DATE: September 4, 2013

TO: Design Review Commission
FROM: Sierra Davis, Assistant Planner
SUBJECT: 13-SC-10 – 691 Benvenue Avenue

This is a revised design review application for a two-story residence.

Re: New residence
691 Benvenue Avenue
Los Altos, CA
Response to Staff Incomplete letter

3.1 Plan, with tree numbers added

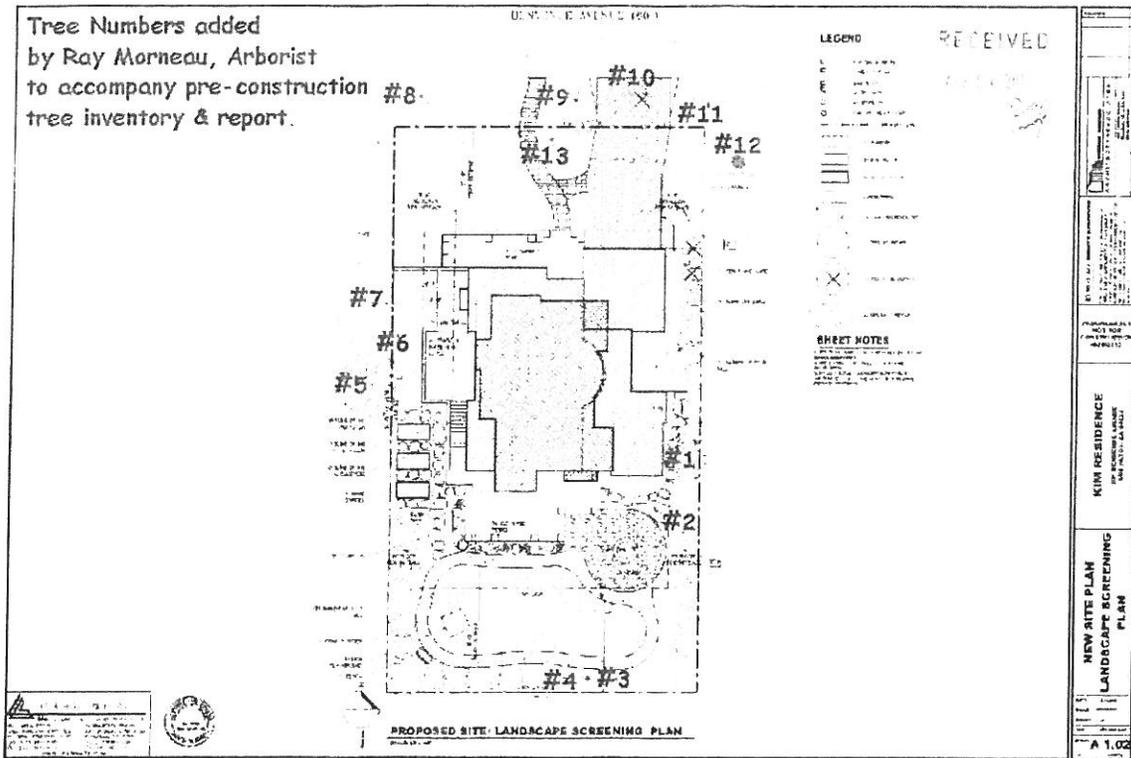
All the trees, except magnolia #10 in the new driveway footprint, can be preserved, per current site plan, A 1.02.
